# Special Bulletin

# SP23-301

## STEERING DAMPER REPLACEMENT

Prevost vehicles

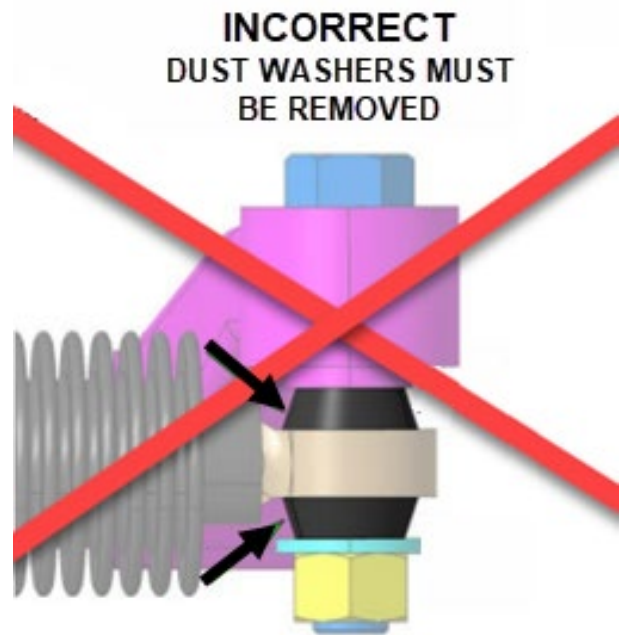
### 1. Validate the damper manufacturing date.

Example: Date Code Q22351

22 is the Year

35 is the week

1 is the day of the week.

- If the damper is manufactured **after Q22351**, the damper is good and does not need replacement (proceed with step 2 of the inspection).
- If the damper manufacturing date is **Q22351 or before**, the damper and all related hardware must be replaced using kit **SP23301-1** (proceed with replacement procedure).

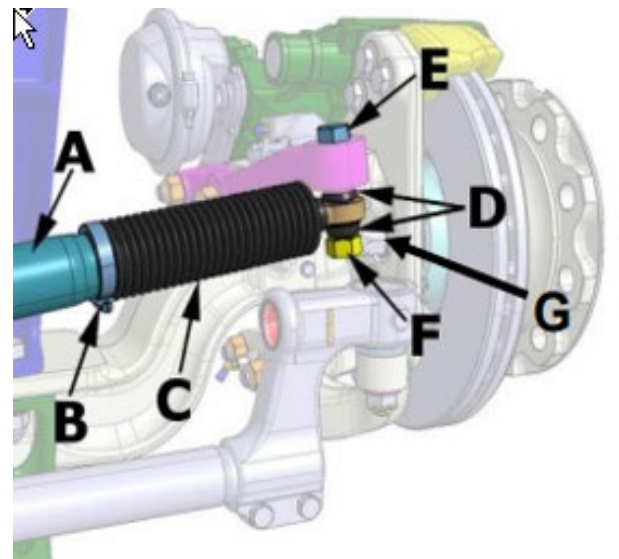
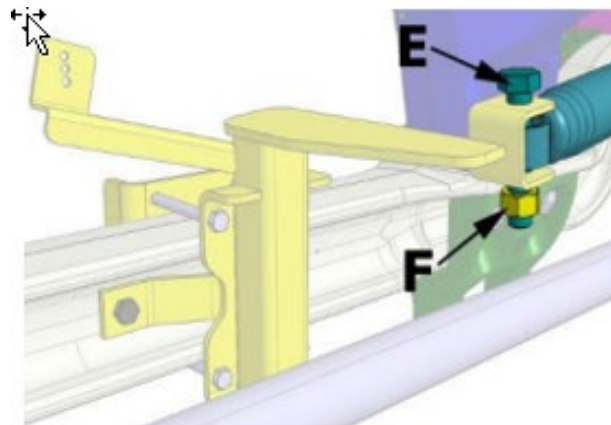
1. Remove and discard the steering damper, mounting hardware and related components listed below.

| A : Steering Damper | B : Clamp       |
| C : Dust Bellow     | D : Dust Covers |
| E : Screws          | F : Bolts       |
| G : Flat Washer     |                 |

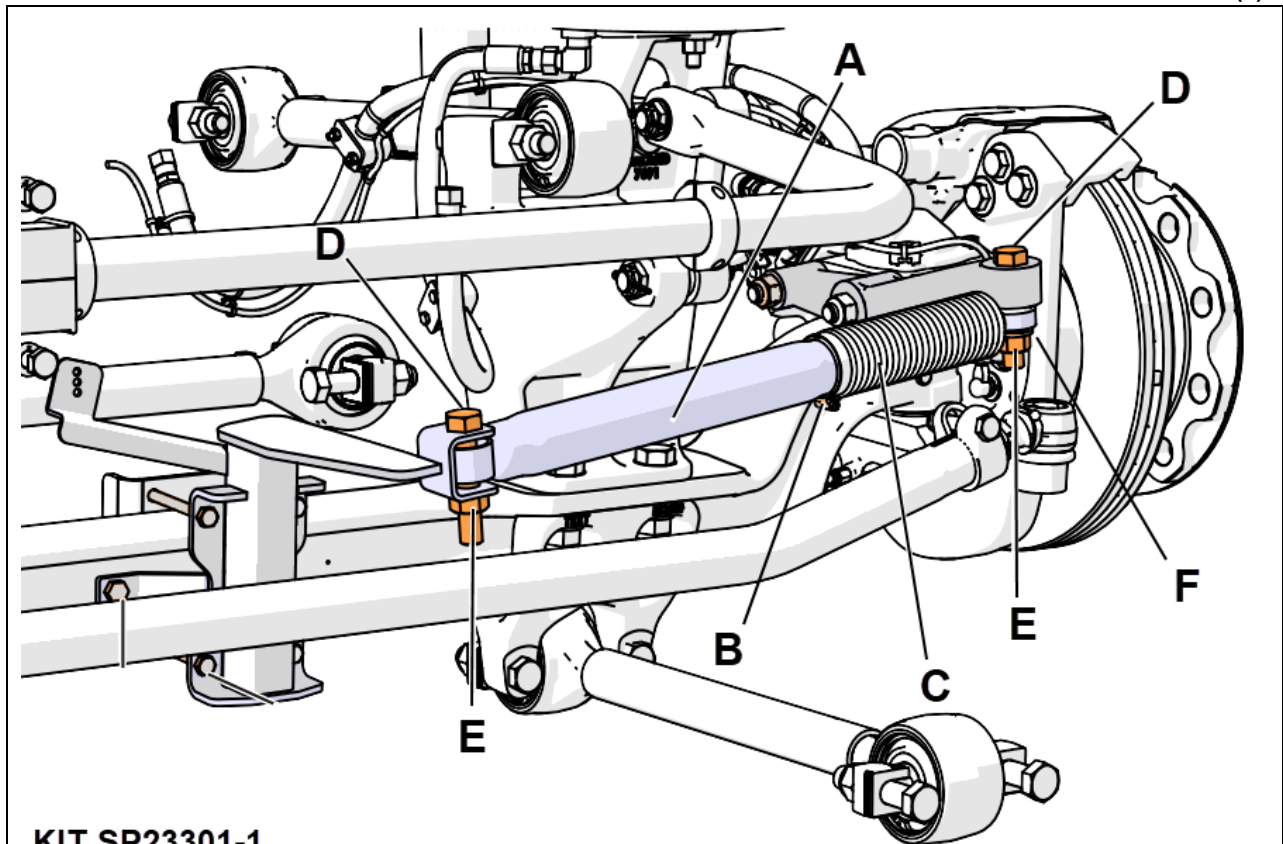
- A : Steering Damper # **660979**
- B : Clamp # **504792**
- C : Dust Bellow # **661007**
- D : Screws # **500146**
- E : Bolts # **500251**
- F : Flat Washer # **500087**

2. Reinstall the new components supplied in KIT **SP23301** as listed and pictured above.

**IMPORTANT:** Make sure that the bellow drip holes and the clamp screw are toward the bottom.

**TORQUE (bolts both ends) : 110 FT-LB**

**TORQUE REQUIREMENT (hose clamp) :**  
**Must not rotate with hand force.**
